To: Steve Foster
From: Mark Irish
Date: 21 December 2020
Subject: Horsley Logistics Park
Response to Additional DPIE Submission

To: Steve Foster
From: Mark Irish
Date: 11 December 2020
Subject: Horsley Logistics Park
Response to Additional Jacfin Submission

Following submission of the NVIA, Jacfin Pty Ltd (Jacfin) has provided a Submission on Response to Submissions Report (HWL Ebsworth report reference PNL:ACS:979050 dated 1 December 2020). This document includes a peer review report from Acoustic Dynamics (report reference 5074L001.BC.201201 dated 30 November 2020).

Figure 1 Modelled Location for Truck Hardstand Noise Source

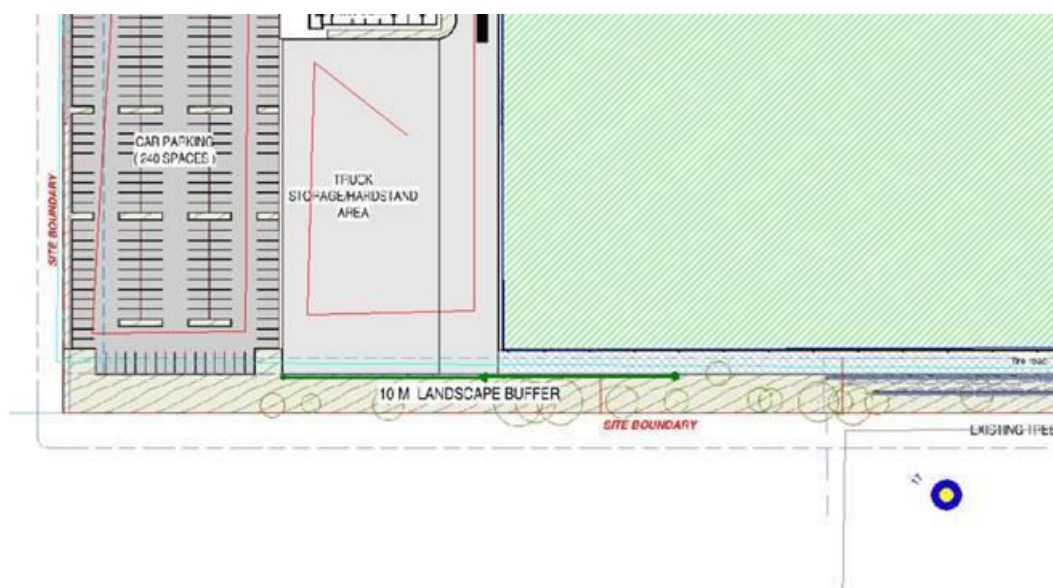
The Revised SLR Report has now modelled for the use of the truck hardstand area located on the southern boundary of the Site. The report proposes that the Development will comply with the Site specific noise criteria provided that a 3 metre high barrier is erected. However, the Revised SLR Report fails to set out the calculation or modelling used to reach this calculation identifying the manner in which these calculations are achieved.

The further acoustic assessment fails to correctly model and properly assess the acoustic impacts associated with the use of the 232 space carpark and truck hardstand areas at the south-west corner of the Site. When correctly modelled, the Development fails to comply with the site specific noise criteria and the sleep disturbance criteria.

Heavy vehicle SWLs were modelled at 103 dB per vehicle as indicated in Table 24 of the report. This noise level is considered representative for a broad range of heavy vehicle types travelling at a range of low speeds from 10 km/h to 30 km/h and is considered a reasonable basis for this assessment, given the current level of detail available for the proposal does not include specific information regarding the type of vehicles associated with each Lot. The heavy vehicle SWL was applied to a 360 m path length around the truck hardstand area for the noise source prediction as shown by the red line in **Figure 1** below.

No exceedances of the LAeq (average noise level) criteria are predicted to the Jacfin land in NCA01 with the indicative 3 m barrier to the truck hardstand, as confirmed in Table 26 and Figure 5 of the NVIA. A noise barrier to the south of the carpark is not required to achieve compliance.
